HOLDOVER - REVISED

Case # SUB2007-00224 ZON2007-02214
ZON2007-02211 ZON2007-02215

**REZONING,
PLANNED UNIT DEVELOPMENT
& SUBDIVISION STAFF REPORT**

DEVELOPMENT NAME Graf Dairy Subdivision

SITE PLAN

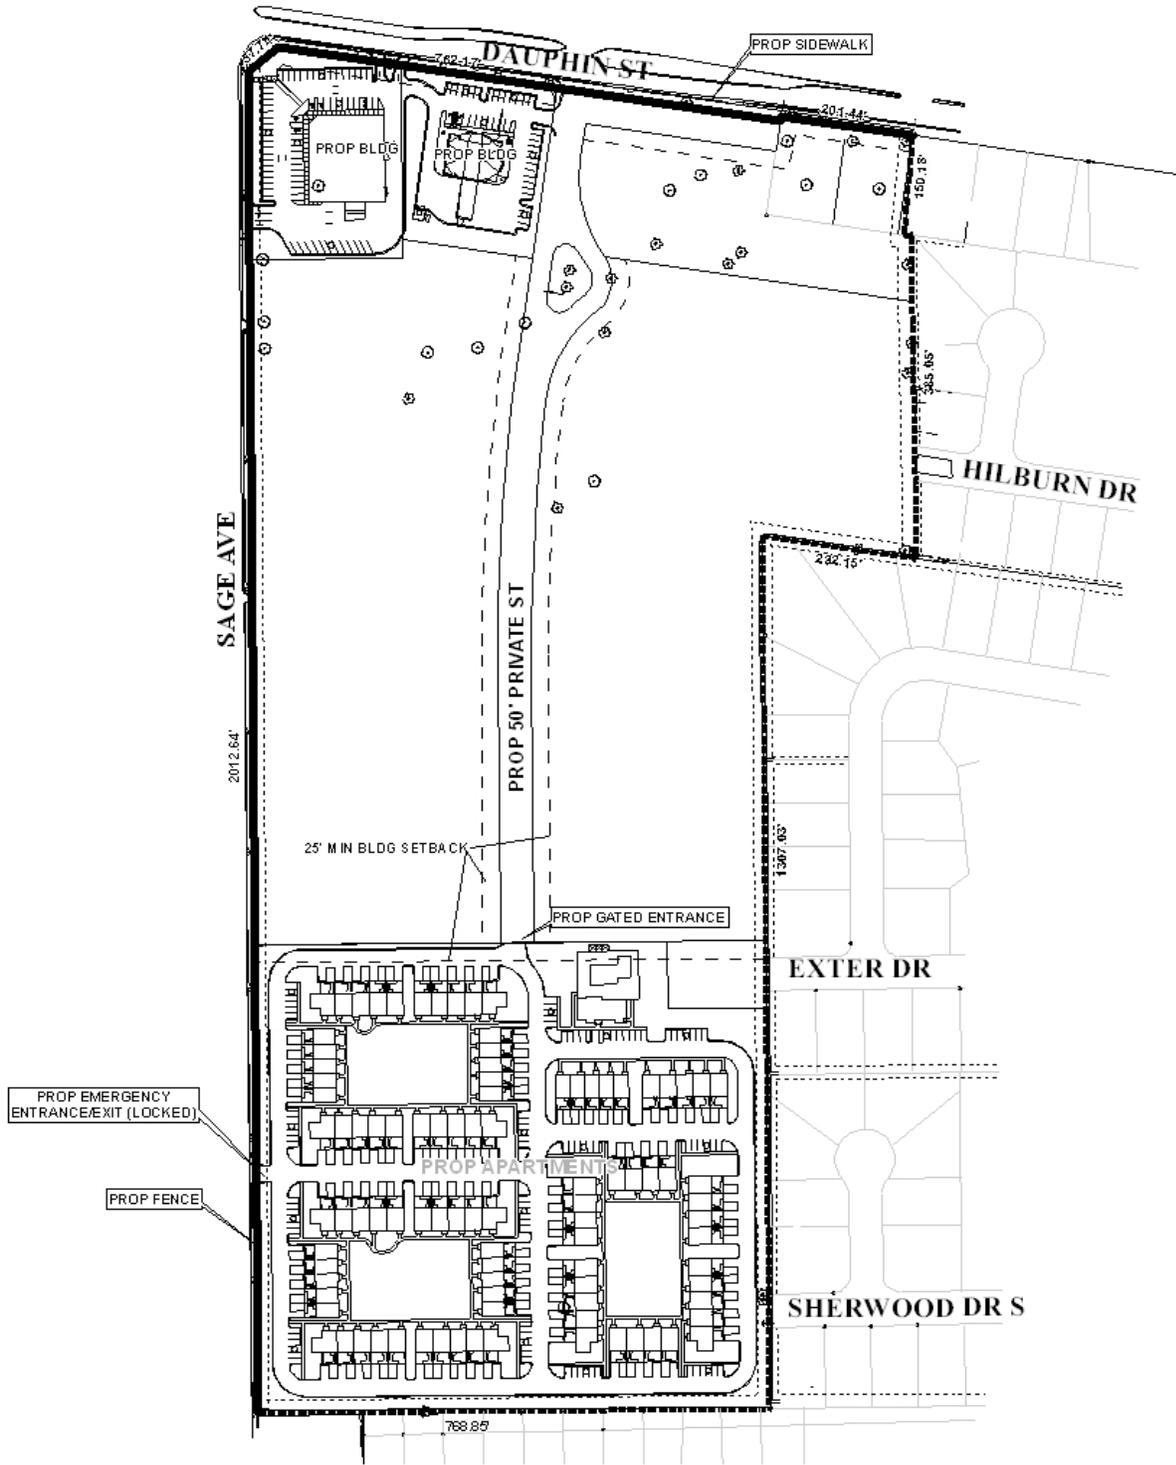
The applicant has submitted a revised site plan addressing some of the issues raised in the September 20th analysis. However, there are other issues that have not been fully addressed, and while not necessarily enough to delay the application, definitely sufficient to reference in these comments.

Another is the actual access from Dauphin Street onto the private street(s) within the development. While an edge of paving is illustrated along the western entrance – from that point, and for a distance of 340', there is no defined access point(s) from Dauphin Street. While there is a note on the plan that state there will be an exit onto Dauphin Street on the East end, more detailed information would be beneficial for review at this time.

While the plan now before the Commission has been revised to provide the 6' privacy fence as suggested by staff, it should be noted that the natural vegetative buffer has also been revised. The plan now illustrates a 20' natural buffer along the East line of the proposed condominium development, and a 10' natural buffer along the East line of the proposed B-2 property that is adjacent to a single-family residential neighborhood to the East.

The plan illustrates several large trees, the most significant of which are two 66" live oaks. The applicant has designed the private street such that these trees are protected in an island which appears to be of substantial size. These trees should be given preservation status (All work under the canopies is to be permitted and coordinated with Urban Forestry, removal to be permitted by Urban Forestry only in the case of disease or impending danger), and if any modifications to the landscaped island are needed to help preserve the tree, they should be Coordinated with Urban Forestry.

Detention facilities are not shown on any of the proposed lots or developments, but will likely be required. If the detention facilities require significant modifications to any of the plans as proposed, those individual developments will be required to resubmit to amend the PUD since PUD approvals are site plan specific.

As referenced in the previous analysis comments, there is no indication on the site plan (with the exception of Lot 2) as to the proposed location of any dumpster or other waste storage facility. If the applicant utilizes a dumpster, the location of the storage area for the dumpster must be indicated on the site plan, and the location and required screening must comply Section 64-4.D.9. of the Zoning Ordinance, as well as with all other applicable regulations. Additionally, there is no indication on the site plan as to the proposed location of any mail kiosk. This is one point that the applicant may want to pursue with the USPS, because traversing the private street to access the condominiums may be an issue.

Another concern that has not been addressed by the application or plan is the standard to which the proposed private street is to be constructed. Given the volume of traffic that is to be expected on this street – both residential and commercial – it would seem appropriate that the private street be constructed to City of Mobile standards.

3. *provision of an 20' natural buffer with a 6' high wooden privacy fence along the entire East property line;*
4. *Compliance with Fire Department Comments (must comply with the requirements of the 2003 International Fire Code, including Appendices B through D, as adopted by the City of Mobile, and the 2003 International Existing Building Code, as appropriate. Fire hydrants shall comply with Section 508.5.1 of the 2003 IFC. Dead ends shall comply with Table D105.1 of the 2003 IFC);*

6. *revision of the PUD plan to include placement of a note stating that the two 66" oak trees are given preservation status (All work under the canopies is to be permitted and coordinated with Urban Forestry, removal to be permitted by Urban Forestry only in the case of disease or impending danger), and if any modifications to the landscaped island are needed to help preserve the tree, they should be Coordinated with Urban Forestry;*

7. *construction of the private street to City of Mobile standards;*
 8. *construction and repairs of sidewalks along Dauphin Street and Sage Avenue as necessary;*

9. *full compliance with all municipal codes and ordinances; and*
 10. *submission of a revised site plan reflecting these conditions prior to the issuance of any permits.*
